COUNTY OF VENTURA PUBLIC WORKS AGENCY WATERSHED PROTECTION DISTRICT ZONE 2 "J" STREET DRAIN IMPROVEMENT ORMOND BEACH LAGOON TO DOWNSTREAM OF HUENEME ROAD IN THE CITY OF OXNARD

SAVE DATE: 5/21/13 DOKTORN K:\PC\PROJECTS\82322 J STREET DRAIN IMPROVEMENT\FINAL DESIGN\DESIGN DRAWINGS\100%ADDENDA\ADDENDUM NO. 1\JSD-01-GP.DWG

"J" STREET DRAIN IMPROVEMENT
ORMOND BEACH LAGOON TO
DOWNSTREAM OF HUENEME ROAD
GENERAL PLAN

SHEET	7E
OF	31
DRAWING NO.	Y-2-3711E

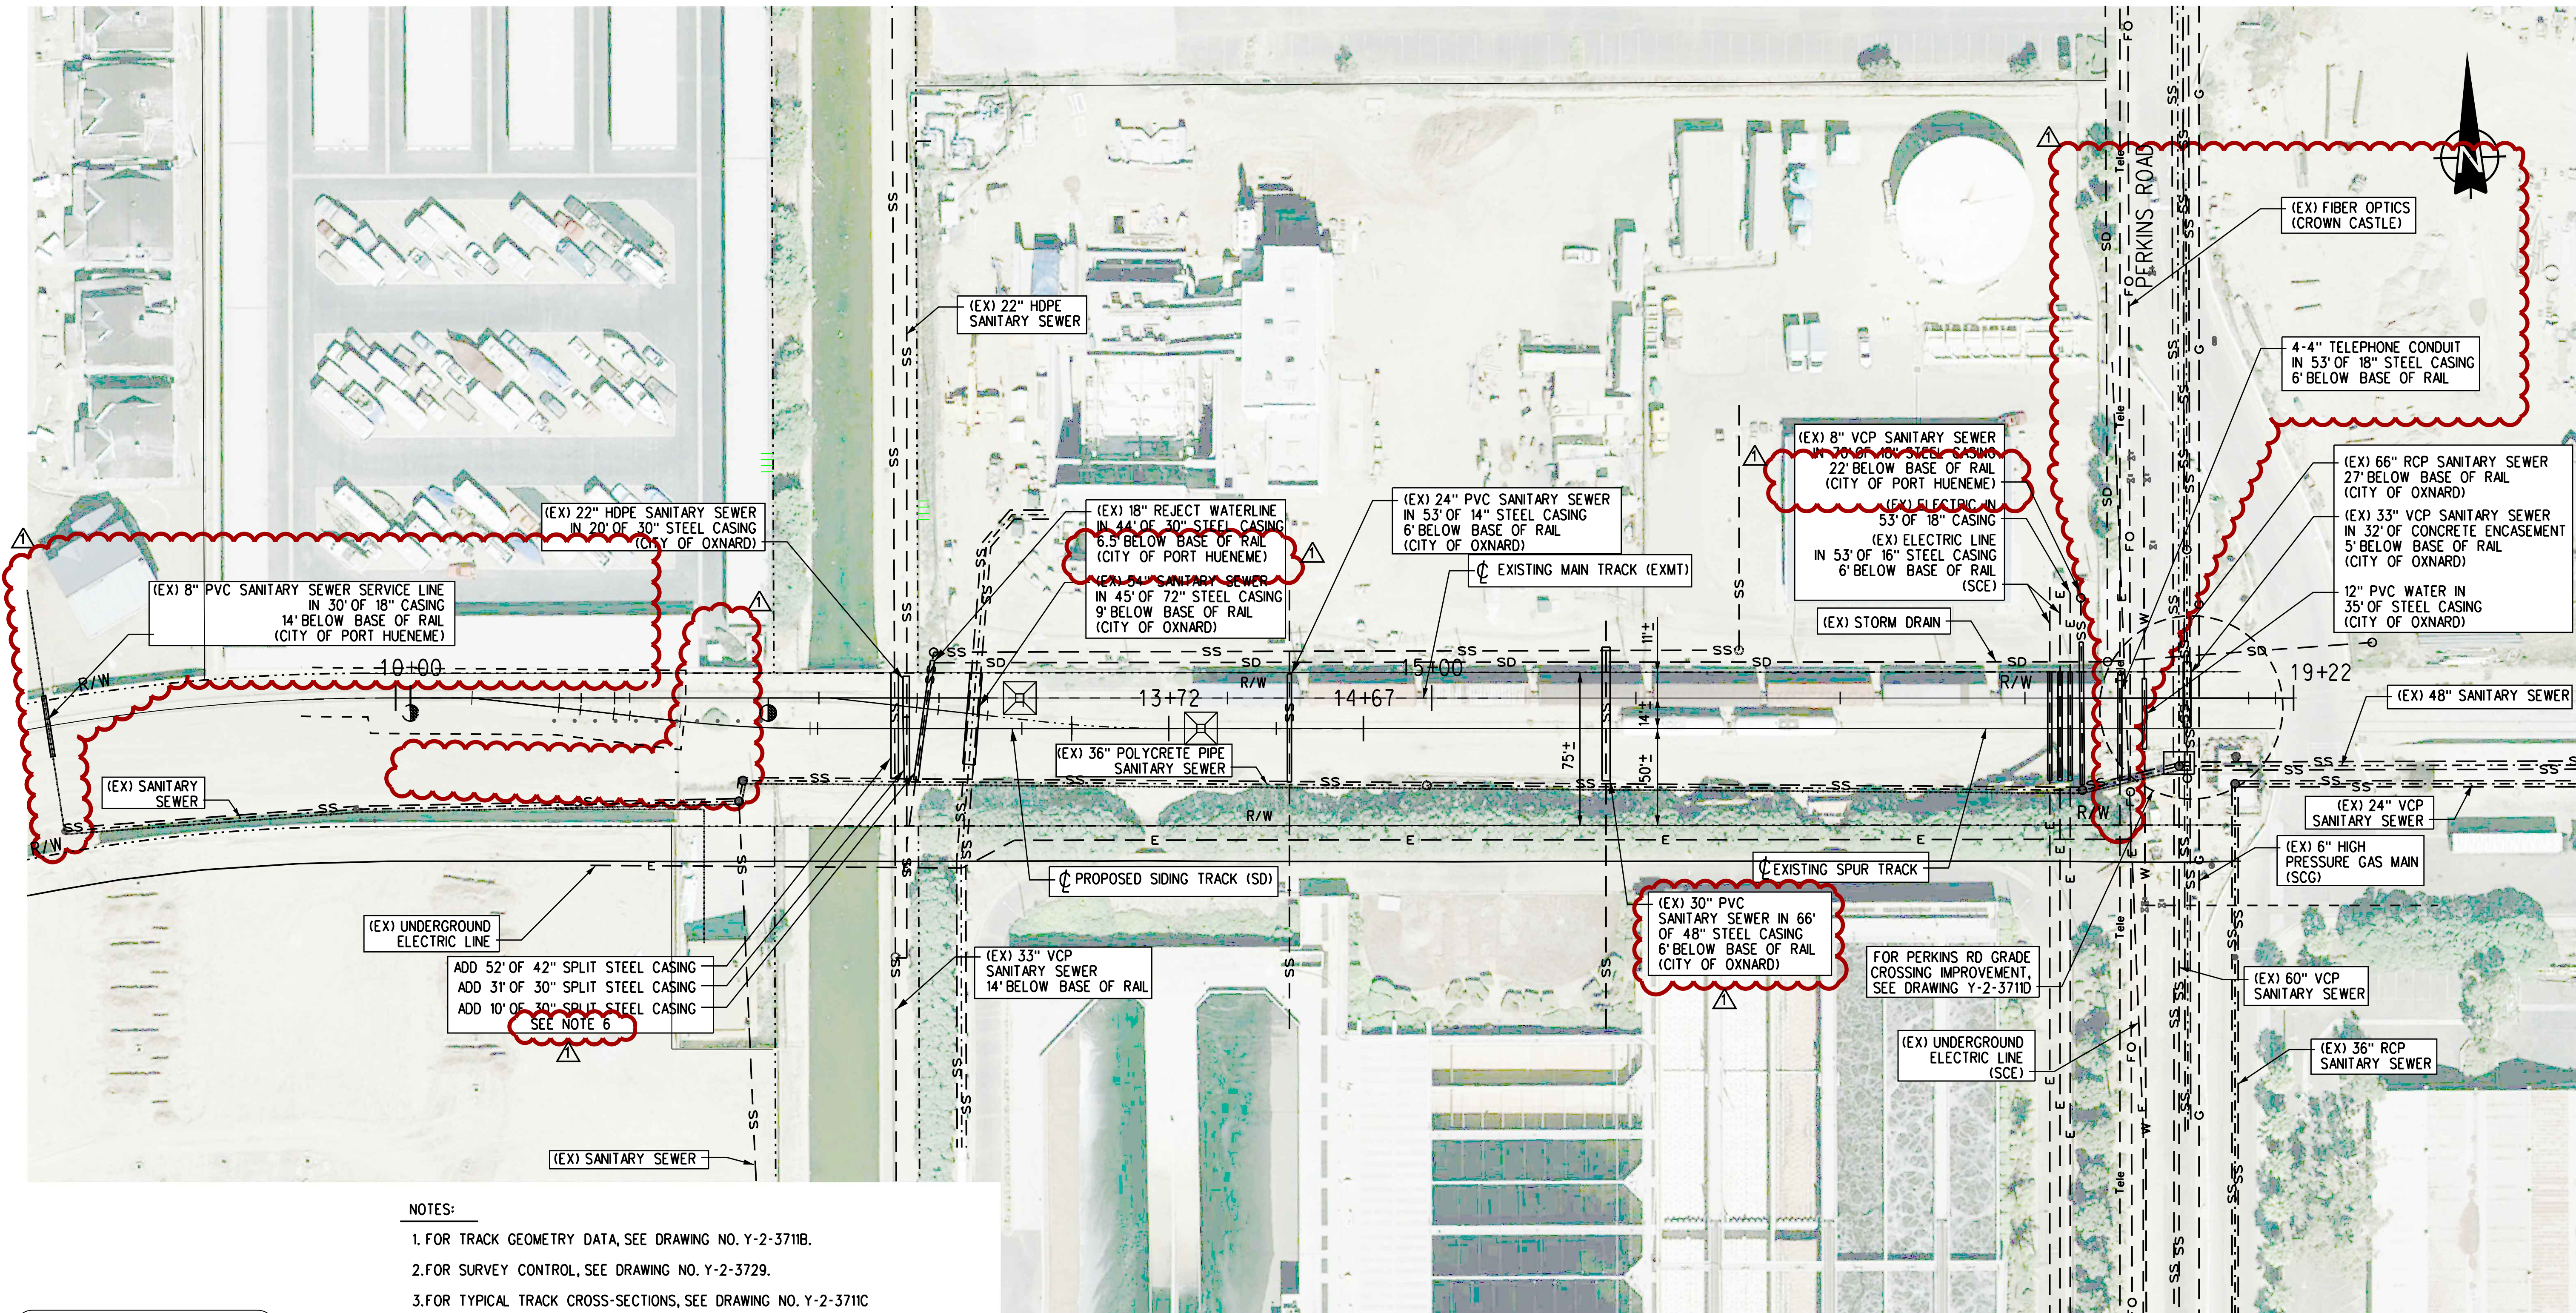
REVISION	DESCRIPTION	APP.	DATE
1	REMOVE 25 LF 18\"	EML	06/21/13
